Washington Public Power Supply System

Subject: NUCLEAR PROJECT 3
RESPONSES TO NRC QUESTIONS

NUCLEAR PROJECT 3 RESPONSES TO NRC QUESTIONS

FIGURE
6.2-36b

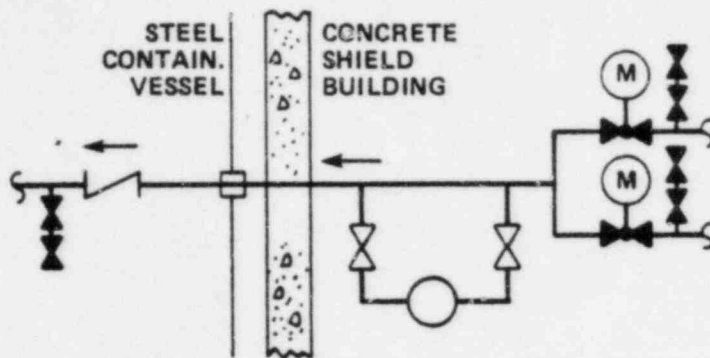
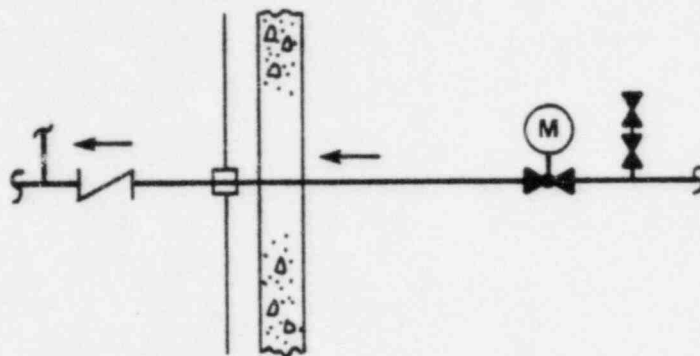
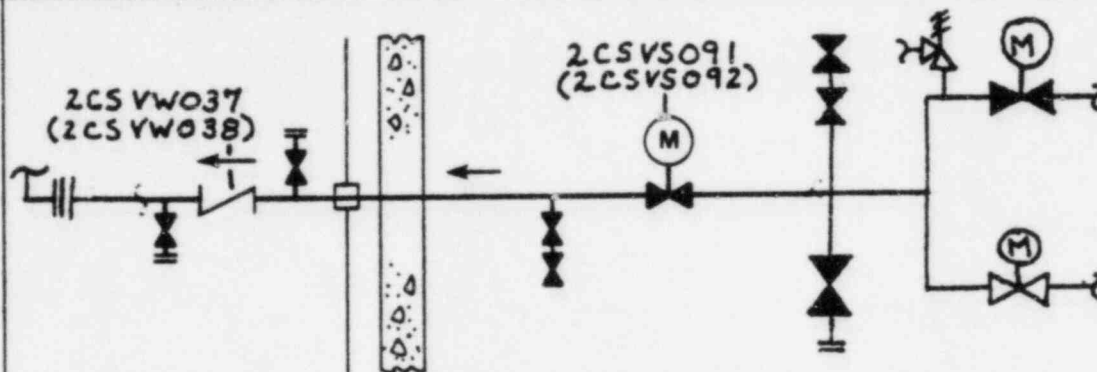
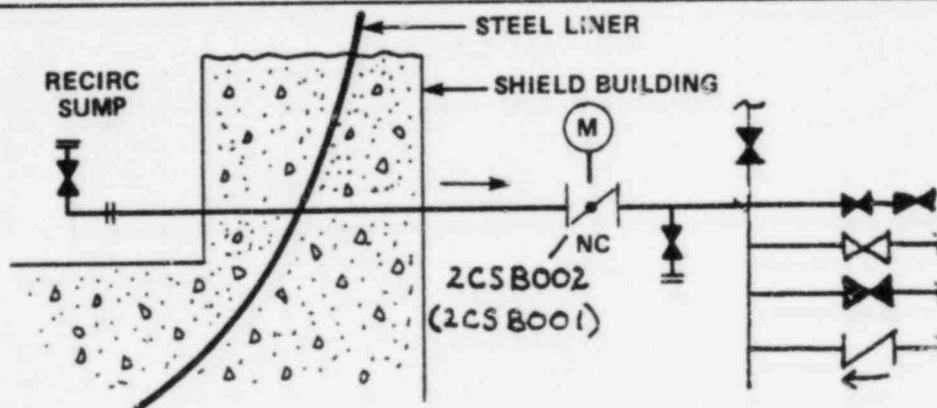
480.18 Provide a tabulation of those containment isolation valves for
(6.2.4) which provision has been made to allow them to be individually
leak tested, in the correct direction.

Containment Isolation Valves which have provisions for leak testing are shown on Table 480.18-1.

FSAR Figures 6.2-36b - k, m, o and p and Table 6.2.4-1 will be revised as shown.

{ Containment isolation valve arrangements and indicate those valves for which test provisions have been provided for individual leak testing.
